CITY OF HOBART

TUESDAY, 27 JULY 2021

2.1.1 100 PINNACLE ROAD, MOUNT WELLINGTON AND 30 MCROBIES ROAD, SOUTH HOBART AND ADJACENT ROAD RESERVE PLN-19-345 - FILE REF: F21/57583

Address:	100 Pinnacle Road, Mount Wellington and 30 McRobies Road, South Hobart and Adjacent Road Reserve
Proposal:	Cableway and Associated Facilities, Infrastructure and Works
Expiry Date:	29 July 2021
Extension of Time:	Not applicable
Author:	Emma Riley

Figure 3 Extract: 1782_DA101 SITE PLAN & DRAWING SHEDULE

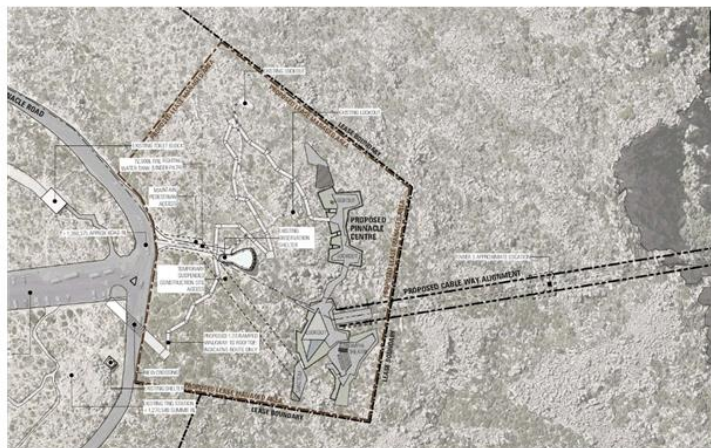
- 4.1.2.2 The Site Plan provides an indicative route for the proposed 1:20 walkway to the rooftop. The proposed ramps and lookout junctions are in lieu of the existing walkway and lookouts.
- 4.1.2.3 The removal of the existing walkway will require remediation of generated disturbance. Where geology has been disturbed there will be visible long-term effects. Newly disturbed vegetation and areas that have existing vegetation disturbance will gradually rehabilitate, though given the exposed nature of the Pinnacle Area growth rates are slow, so natural mitigation will be a medium to long term process.

Figure 4 Extract: 1782_DA201 BASEMENT PLAN

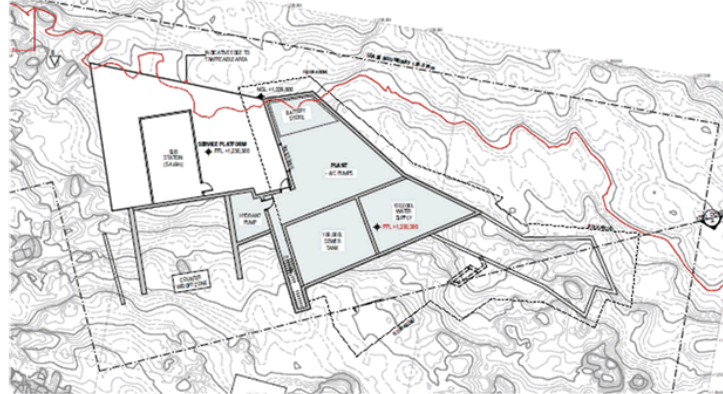
- 4.1.2.9 Given the visual sensitivity to the eastern aspect caution needs to be exercised when considering how this exposed built form will present.
- 4.1.2.10 This visual presentation of the "basement" for the eastern aspect as well as the southern aspect is made relevant by P9.1 Building Design: For any building greater than 3.5m as it effects the visual bulk of the building in relation to the height above NGL.

- 4.1.2.11 The walls of the Basement Level below the Restaurant are stone clad assisting with the integration into the rocky terrain and ameliorating the substantive height above natural ground level of the restaurant Level on Level 0.
- 4.1.2.12 The concrete finish below the Cable Car Platform provides a less integrated resolution and in concert with the same area on the level above and the cable mechanisms provide a visually contrasting component of the proposed development as seen from the eastern VCZ's.

Figure 5 Extract: 1782 DA202 LEVEL 0 PLAN

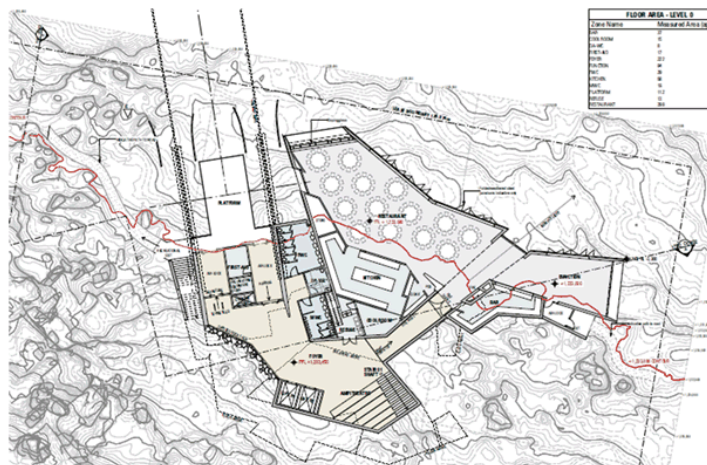
- 4.1.2.13 1782_DA202 The Level 0 FFL is noted @ FFL+1,233,000 at the southern extent the NGL is noted as being -3,300 below. (NGL being + 1,229,700)
- 4.1.2.14 Below the sloping glass eastern extent adjacent to the ledge of the PLATFORM the NGL contour is +1,229,400 being 3,900mm above the Natural Ground Level.
- 4.1.2.15 This level has an external materials palette of weathered steel panels (perforated in front of glazing) as well as the glazed areas of viewing windows.

Figure 6 Extract: 1782_DA203 LEVEL 1 PLAN

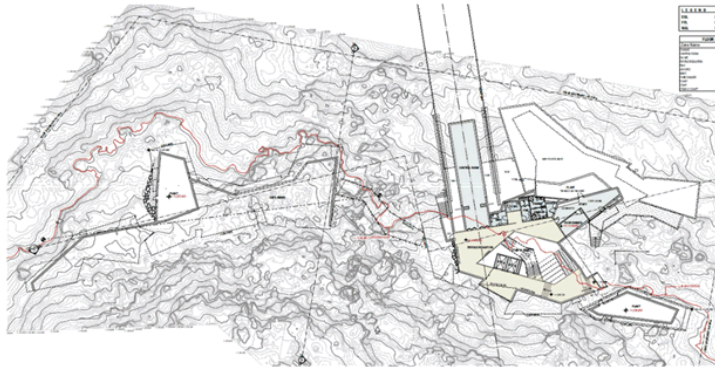
- 4.1.2.16 1782_DA203 The Level 1 FFL is noted @ FFL +1,236,900, this would have the control room floor level +6,650mm above NGL.
- 4.1.2.17 1782_DA204 The Level 2 southern wing FFL is noted @ FFL +1,240,500.
- 4.1.2.18 The walkway bridge links the southern wing to the northern Café. The Café has an FFL of +1,241,000
- 4.1.2.19 The control room roof Level has not been noted on the Architectural Plans, my estimation from the noted levels on the elevations is that it is in the proximity of +1,240,000.
- 4.1.2.20 This would have the roof +3,100mm above the FFL and +9,750mm above NGL at the eastern most extension.

Figure 7 Extract: 1782_DA204 LEVEL 2 PLAN

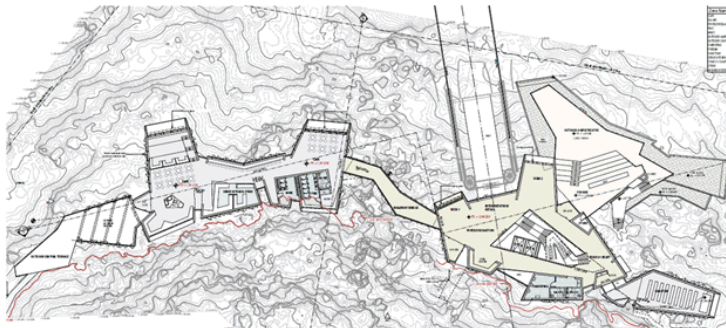
4.1.2.21 The Level 2 Outdoor Amphitheatre FFL is noted @ FFL + 1,237,850, this is consistent with the level noted on the eastern most parapet above the sloping glass section of the restaurant (Level 0).

4.1.2.22 At this eastern most parapet the proposed level is to be + 8,150 above NGL.

Figure 8 DA205 ROOF PLAN

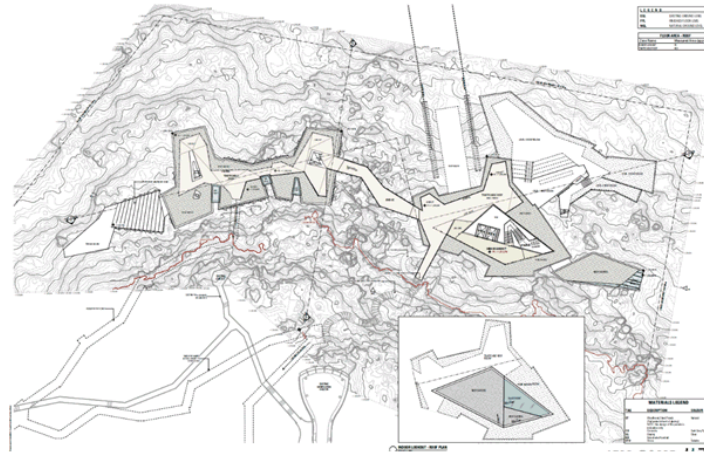
4.1.2.23 The "Roof Plan" has the enclosed INDOOR LOOKOUT @ FFL +1,244,550 as well as a series of continuous TRAFFICABLE ROOF areas @ FFL +1,244,200 , FFL +1,244,500, FFL +1,245,000 and ROOF GARDENS @ +1,244,600.

Figure 11 Extract: 1780_DA00 SITE PLAN & DRAWING SCHEDULE

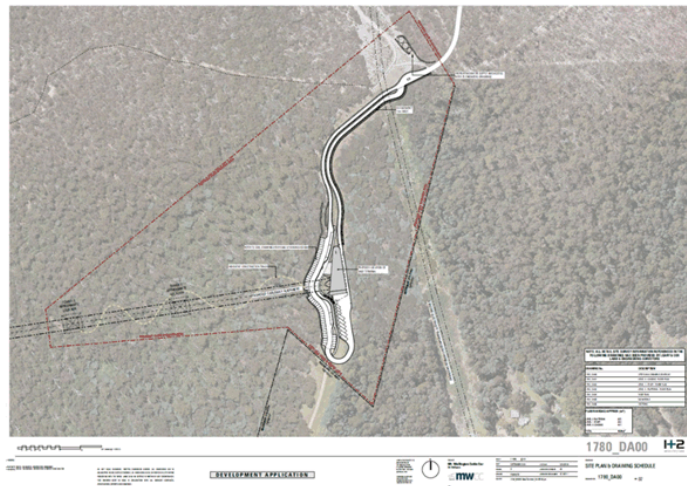
- 4.1.3.1 The proposed site is located in a delineated area that is “Proposed Lease Managed Area”.

Figure 13 Extract: 1780_DA052 ELEVATIONS

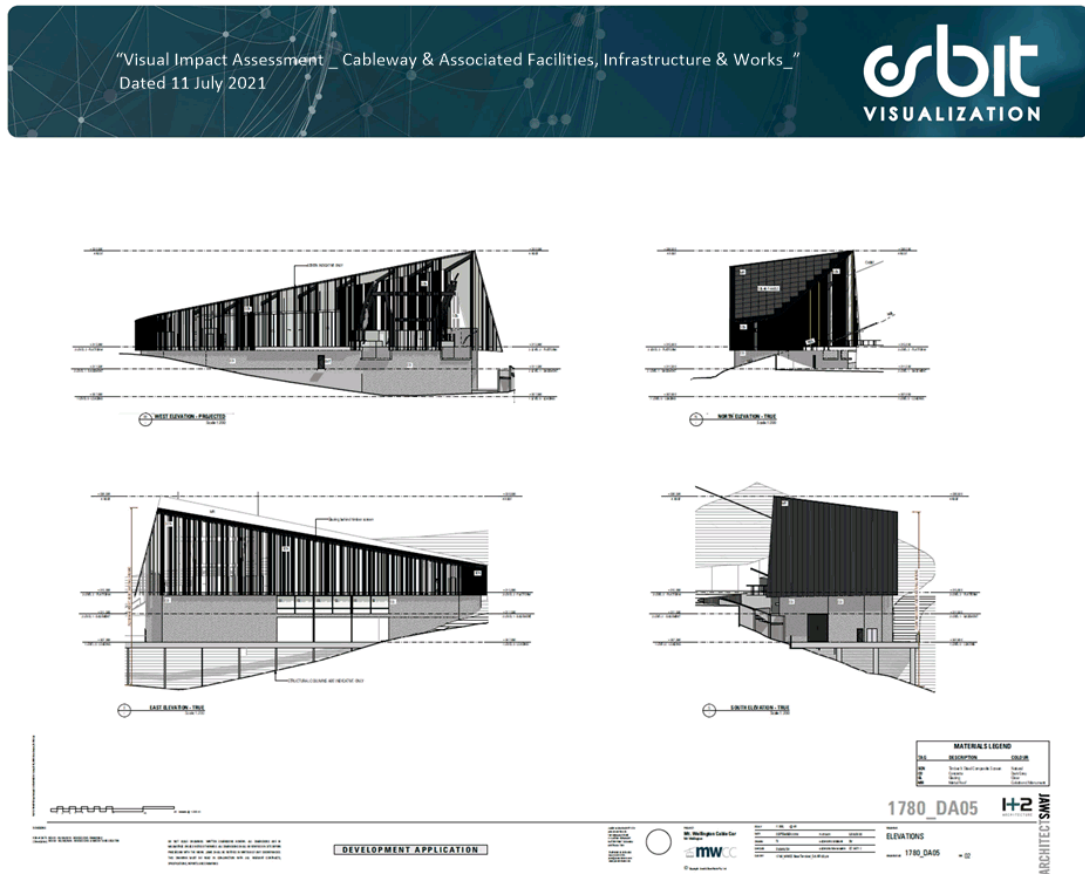
- 4.1.3.2 The building height of the proposed Base Station exceeds the Acceptable Solution of 7.5m as well as the Acceptable Solution under the WPMP. Therefore, the proposal is required to meet performance criteria P1.
- 4.1.3.3 No Desired Future Character Statements are provided for the zone.
- 4.1.3.4 The Base Station and related Infrastructure comprise;
New road from McRobies Road, including underground services.
- 4.1.3.5 New Parking Spaces – 54 proposed for cars, 20 bicycle spaces, 10 bus parking spaces, 5 motor cycle spaces.
- 4.1.3.6 Car park lighting will be provided in accordance with the relevant Australian Standard.
- 4.1.3.7 The proposed Base Station is a maximum of 29 meters above Natural Ground Level (NGL).

Figure 21 Source VP10b H

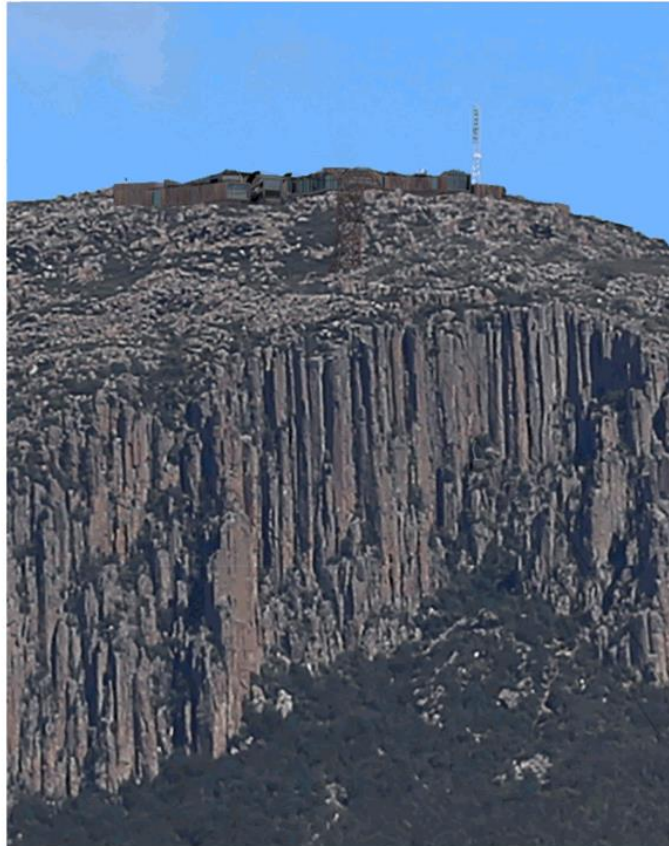
- 5.2.3.4 Line may also be perceptible as shadows thrown by forms onto planes, both built and at grade. This phenomenon will be unmitigated as there is limited landscape vegetation and the undulations of the proposed and existing topography that 'frays the edges' of the planes.
- 5.2.3.5 Of note is that the Cable Car Lines and Tower Three are subject to principle of grouping, where in the Pinnacle Centre is read with them and as a result becomes contiguous in the reading of them together. This cumulative affect significantly increases the reading of the LINE of the proposed built form as well as conflating the permissible uses between the Pinnacle Centre in the Pinnacle Specific Area and the permissible uses in the Natural Zone. In a VIA Assessment process it is generally considered Best Practice to refer to the higher Level.

- 5.2.3.6 Line contrast level would be HIGH.
